30th April 2001

SPIRE-RAL-NOT-000680

DCU Redundancy/Cryoharness

Figure 2

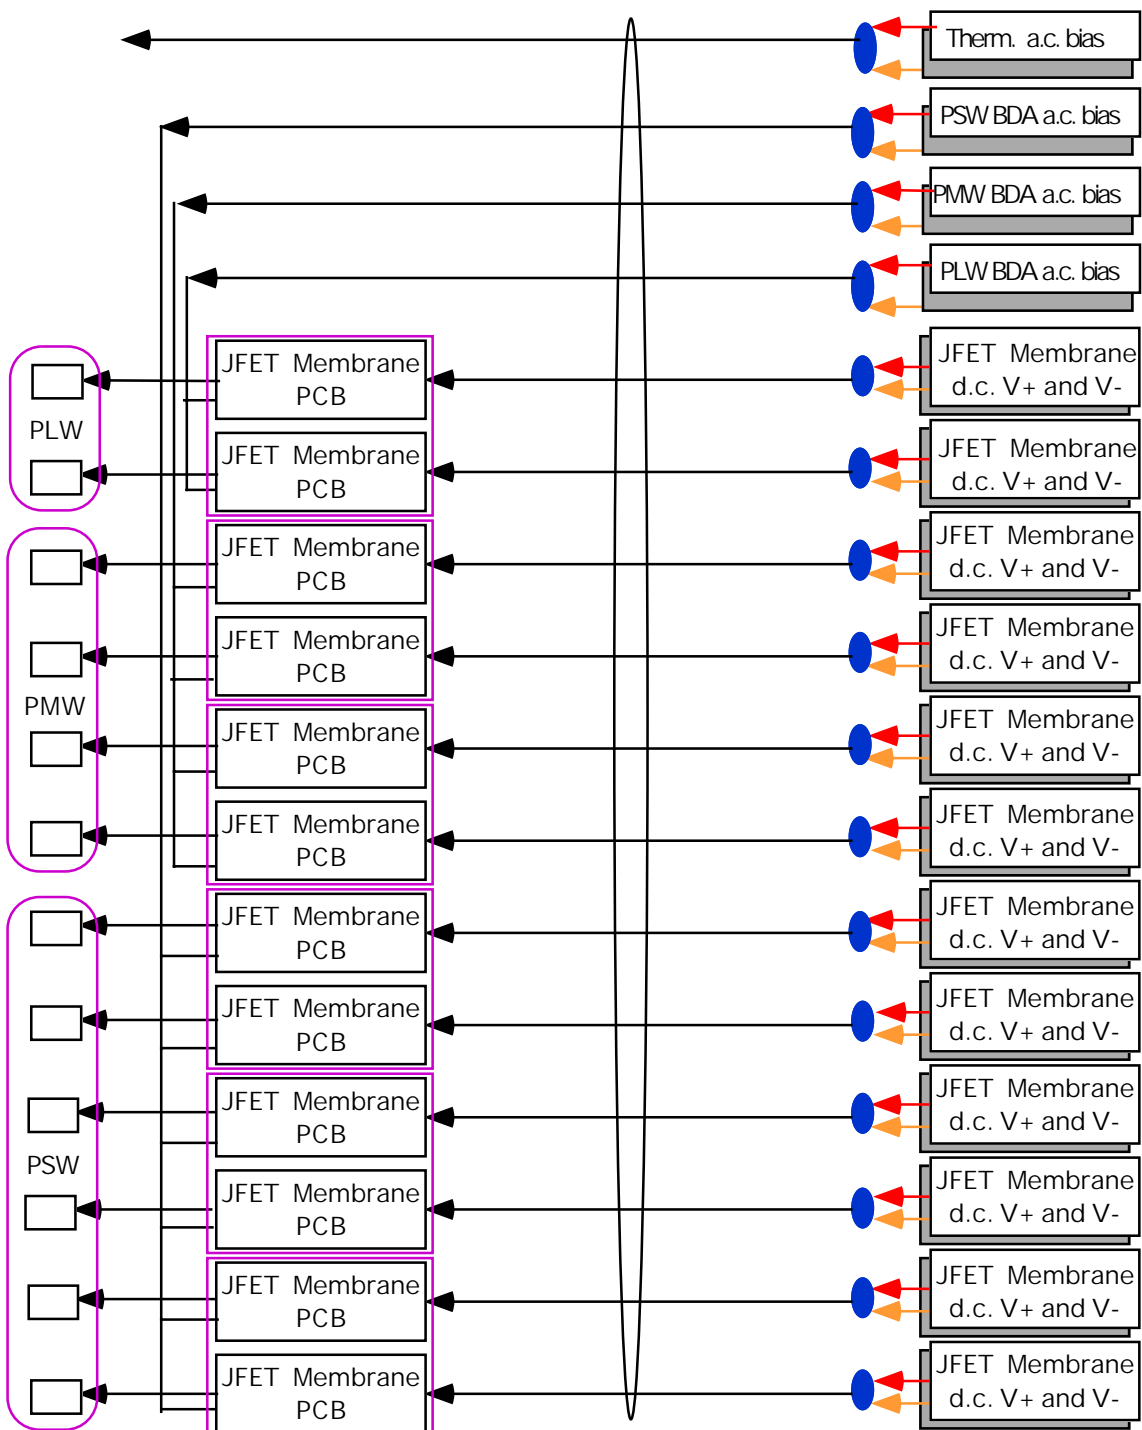
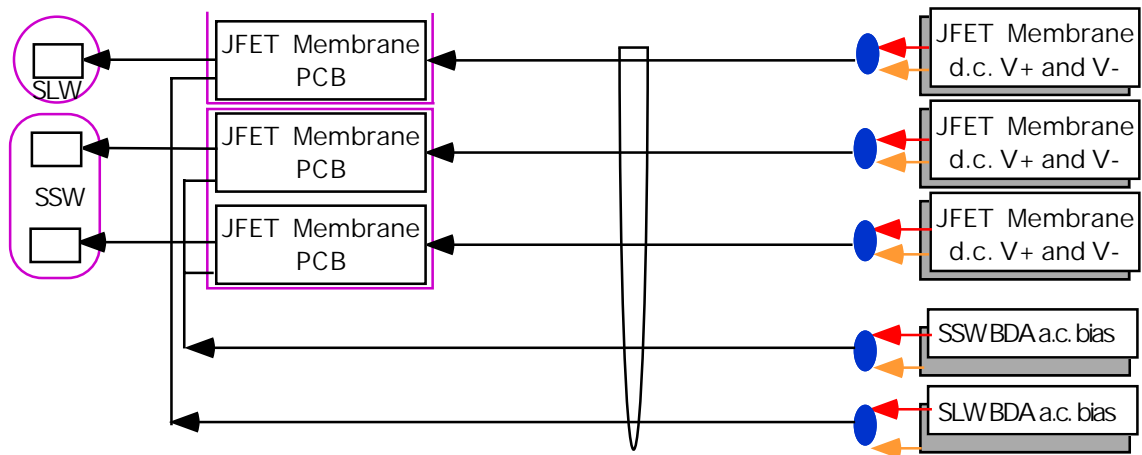
I therefore discussed the situation with Frederic Pinsard, and mentioned putting the Prime / Redundant joints at the warm end as shown in **figure 2**, probably as a little inelegant Y adaptor, to solve my perceived cryoharness problem. Such an approach would mean that double-pinned functions from the JFET Membrane PCBs would pass as 1:1 wires through the r.f. filters (that I have omitted from the figures) to cryoharness pins, rather than needing to divide into two somewhere. Frederic did not suggest that the problem had already been solved because I was looking at things incorrectly, he only expressed a wish to avoid DCU I/F changes. The configuration in **figure 2** results in no such DCU changes at all. I appreciate that JPL knew nothing of this specific proposal re. the harness, but I note that it came to Jean-Louis "to our utmost surprise"!

Figure 3
POSSIBLE SIMPLIFICATION to
JFET BIAS/SUPPLY CONFIGURATION

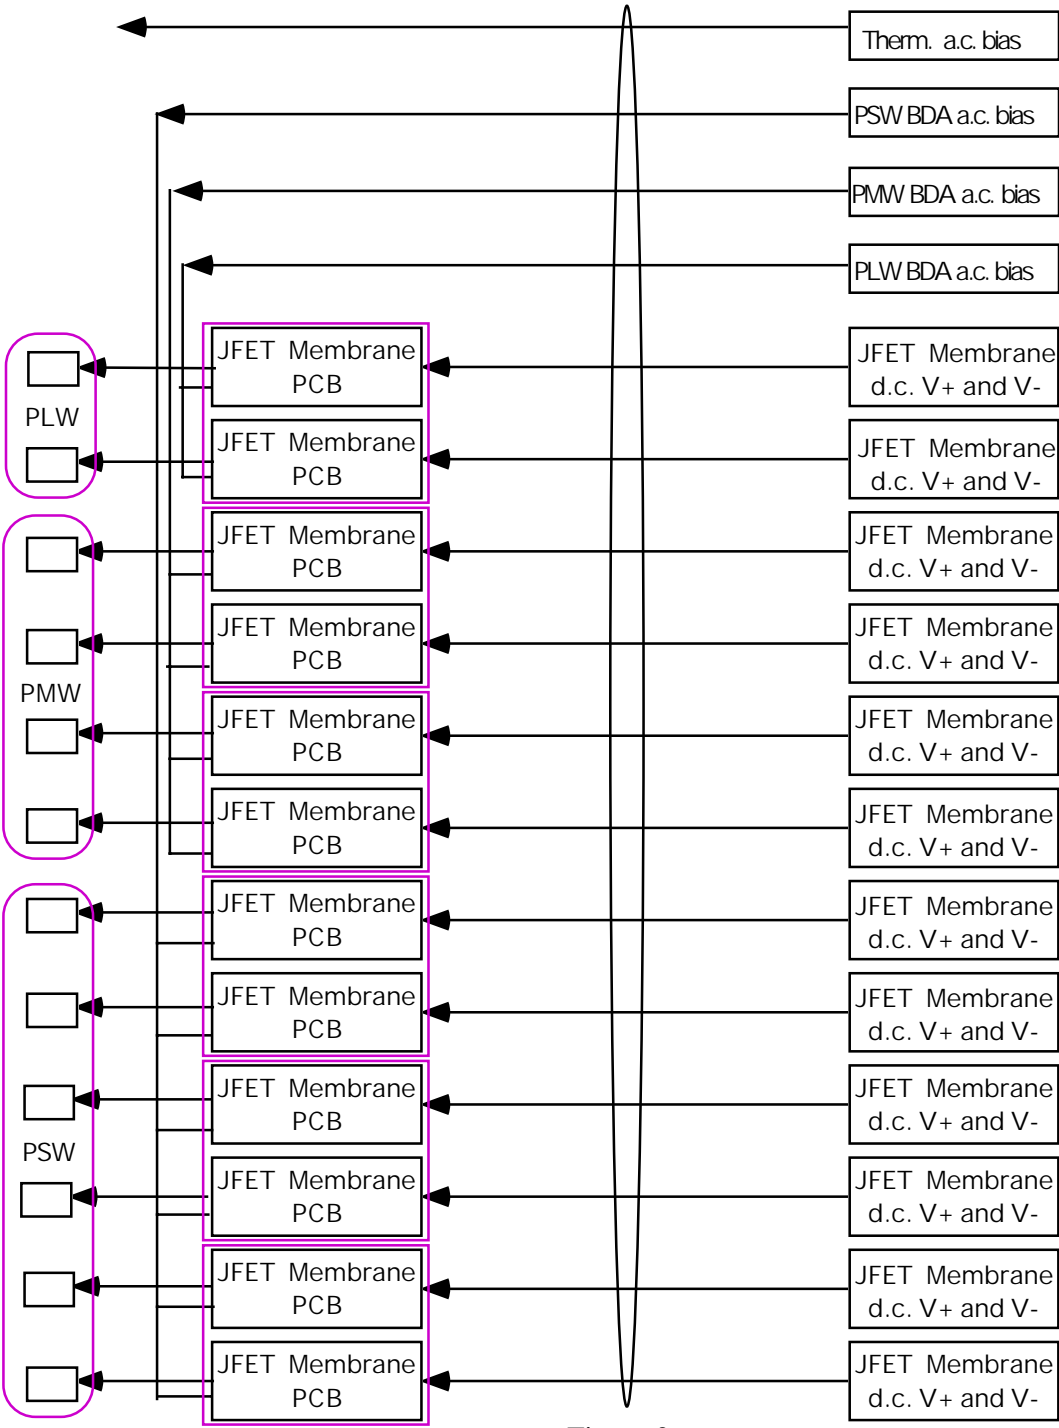
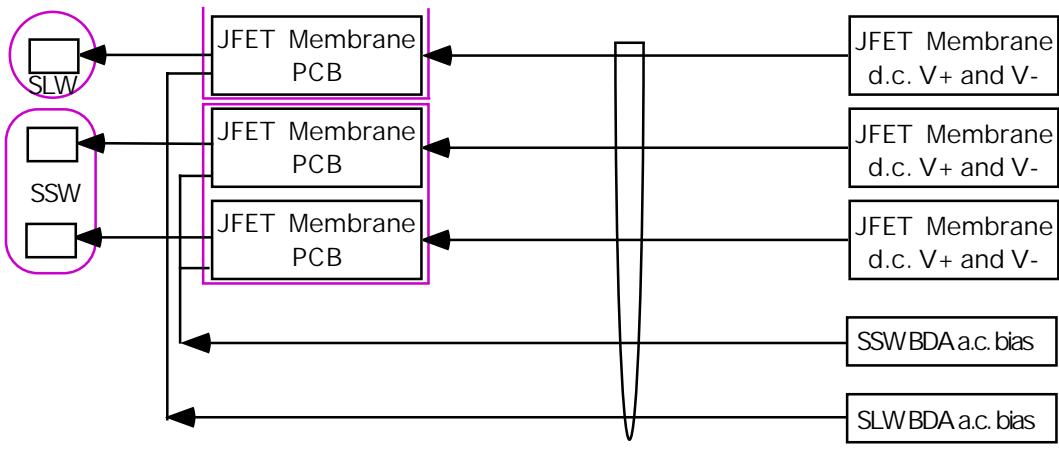
Consider the possible simplification shown in **figure 3**. Bruce had already noted that because of the small fraction of Spire that fails if one JFET membrane power supply were to malfunction, we would almost certainly not take the risk of swapping the whole instrument Prime to Redundant just for such a failure. So the redundancy would probably be redundant! I somewhat simplistically took the view that standard electronics are extremely unlikely to fail, and Spire already has multiplexors and ADCs as major single point bolometer system degradations, so why not remove the redundant units in question. To my mind the configuration has a certain elegance. It also removes unpowered items hanging on sensitive bias and supply lines. Another factor is that if any of the analogue parts of the bolometer are prime/redundant, all ground radiometric calibration must be done fully and properly on both sides of the instrument. Note that figure 3 is only a *possible* simplification.

Figure 4

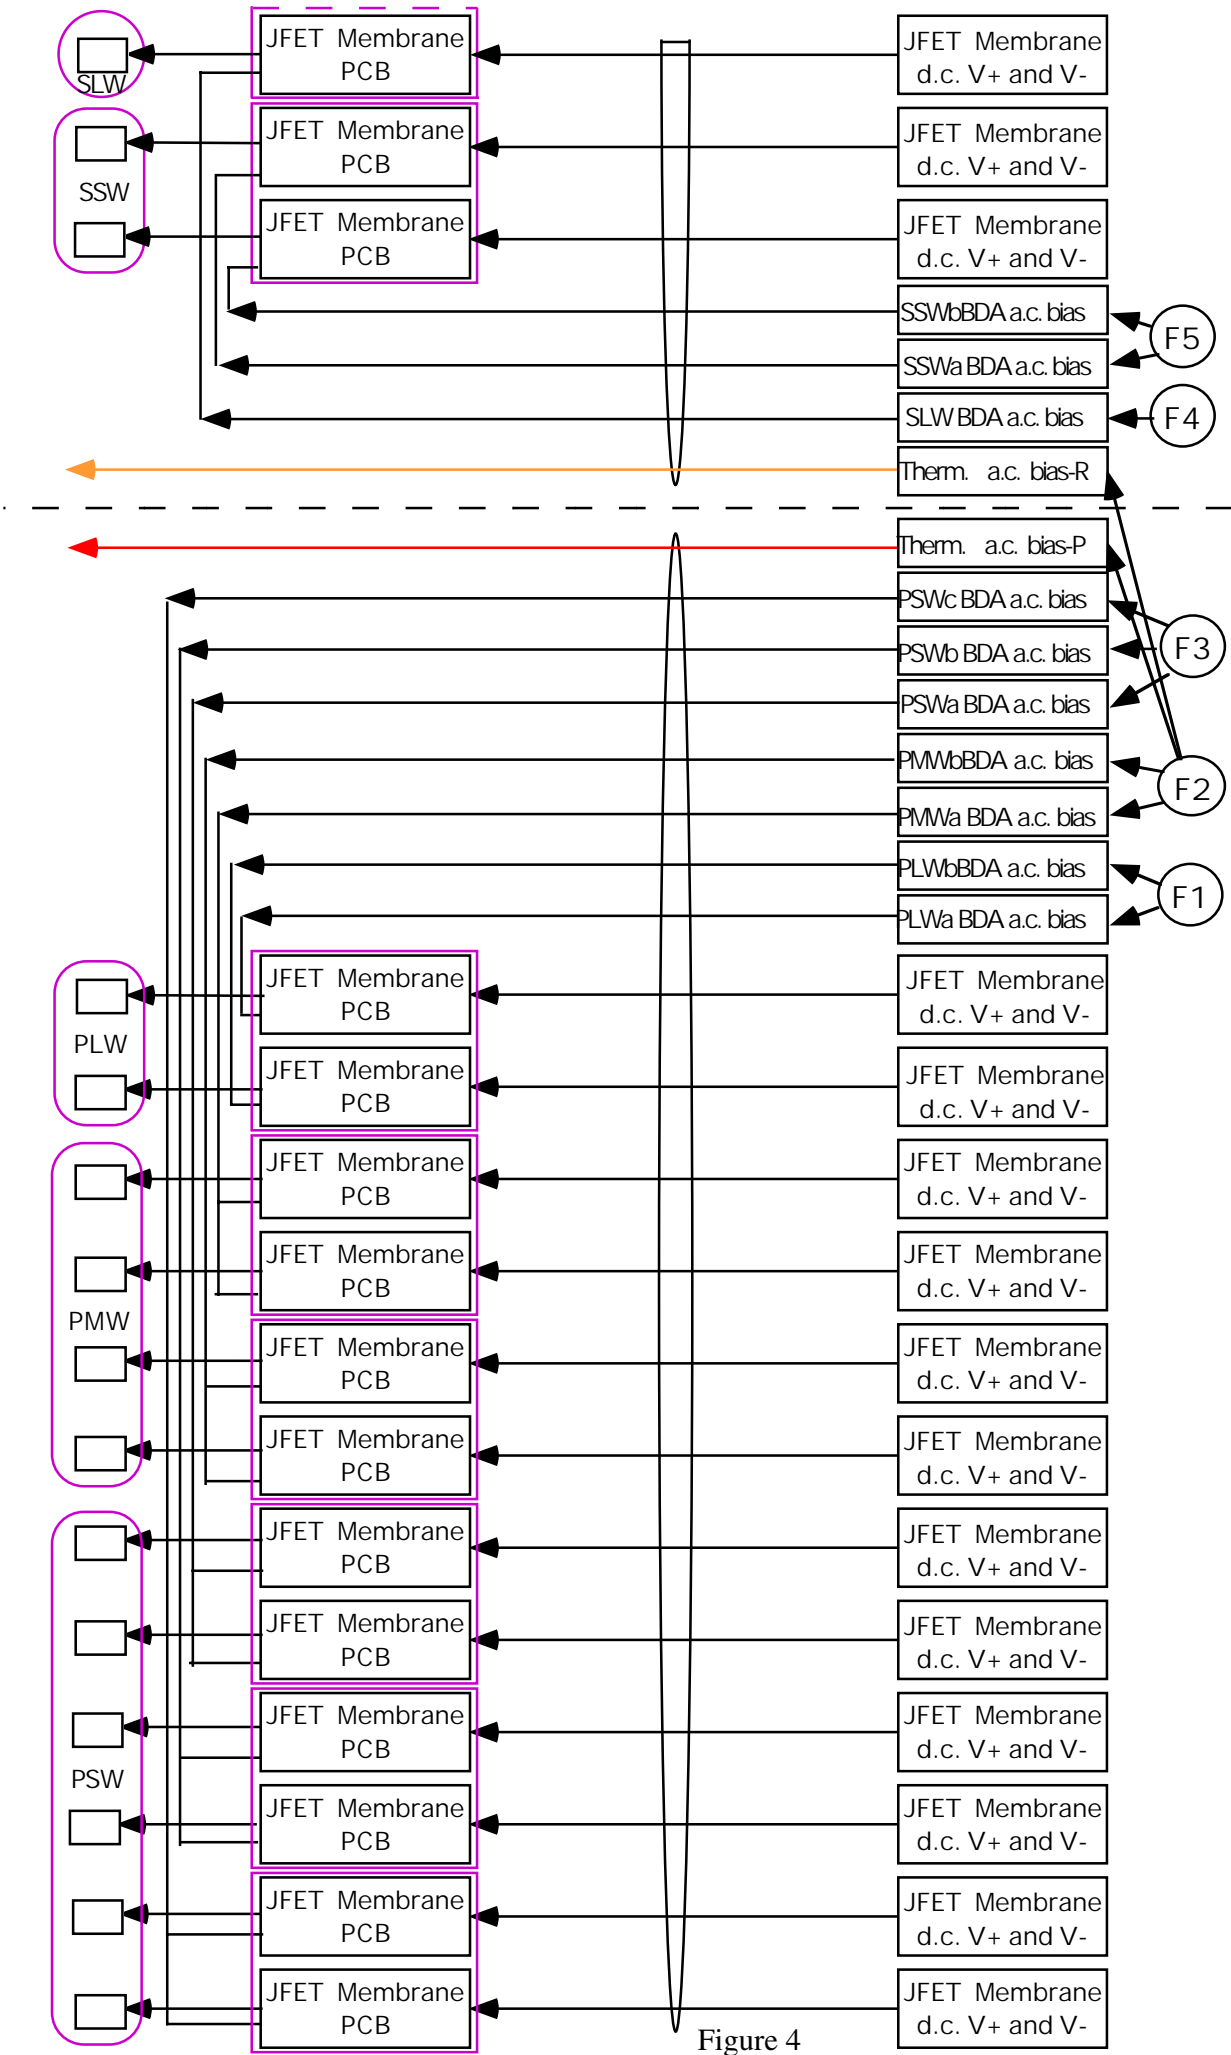
Finally, consider **figure 4**, a suggestion from Bruce (that I have worked through somewhat) in which the redundant JFET supplies are deleted, but all 8 a.c. bias generators remain and are permanently powered as non-redundant. This has the evident advantage of making the instrument degradation in the event of a bias generator failure much more palatable. The damage caused by a single bias generator failure is limited to one or two JFET Membrane PCBs, and only in the case of the SLW does a whole detector drop out. The system is still able to provide Prime and Redundant temperature control thermistor conditioning, actually hot redundant, if this is needed to fit in with Prime/Redundant FCU and DCU systems.

For noise control we clearly only want one frequency present at one phase in each BDA, which means that if the figure 4 configuration were to be adopted the common frequency generators shown on the r.h.s. become other examples of items with wide failure consequences, having just the same impacts of those of the bias generators in figure 3!

REV. IDEA FOR JFET BIAS/SUPPLY CONFIGURATION

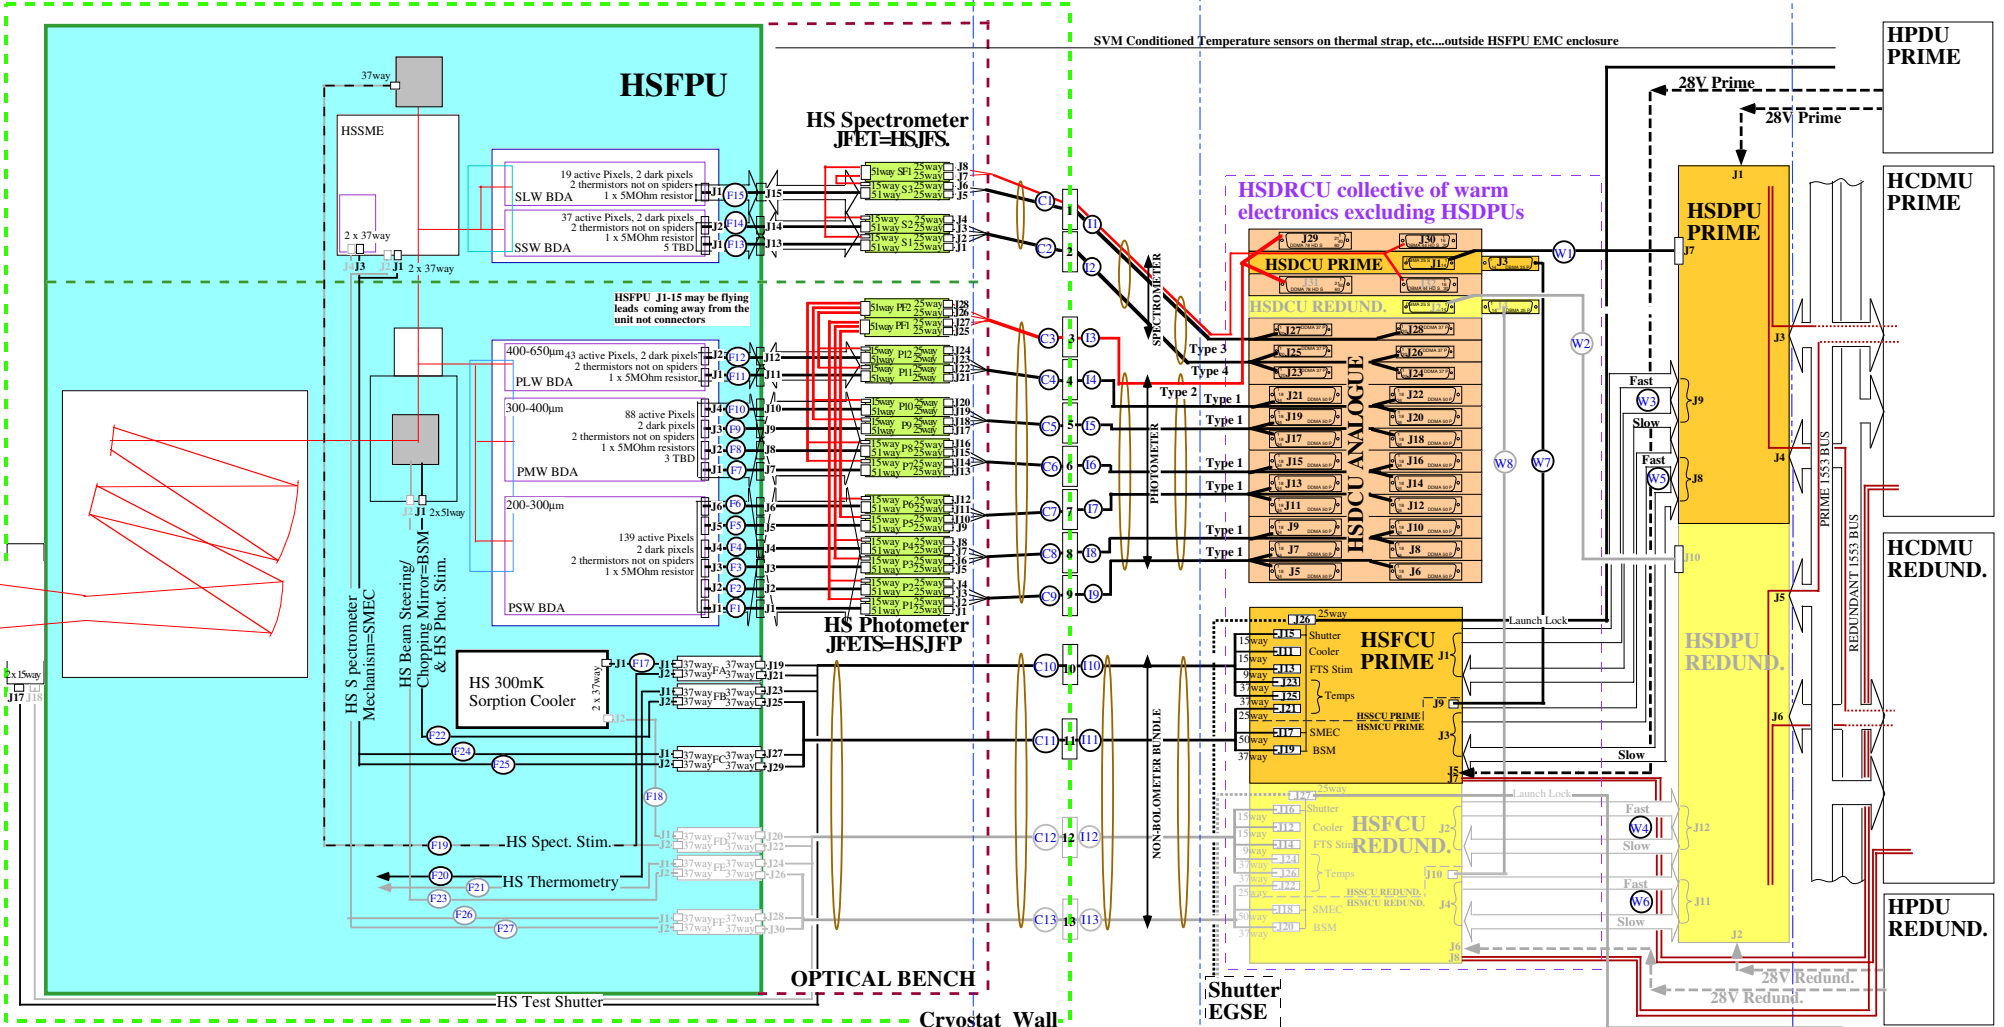
There is one further move towards elegance that should be considered. There can be two identical looking JFET type modules for the Spectrometer and 7 for the Photometer if in the Spectrometer one of the JFET Membrane PCBs were to have no membrane/aperture and just tracks across this area, and two identical items were used in the Photometer. This would match 4 x 25way MDMs on each module to 100 way CVV connects all across the bolometer cryoharness, require Berend's frames to only hold shape of unit faceplate, fully use the half unused JFET module in the Spectrometer, etc.. I hope we can adopt this and no-one will rule it out because it's making filters with 25way connectors instead of the decreed 37ways (we keep the 37ways in non-bolometer filters mounted in the FPU). Hopefully with the signal channel 25ways now as in the harness spec. a well structured 51way MDM the other end of the modified JFET module would permit a flat ribbon configuration for the back-harness without non-interleaved function conductors or other PCB adjustments. I attach a possible system block diagram for this scenario.

Tidy Shutter Wiring

Identify JFETS boxes & Bol Filters and draw to imply JFET module style JFET filters.

Tidy Red Back-harness Wiring

Temp. Control Thermistor and JFET temps. still to sort.

Get DCU SCU/MCU connectors the correct way around.
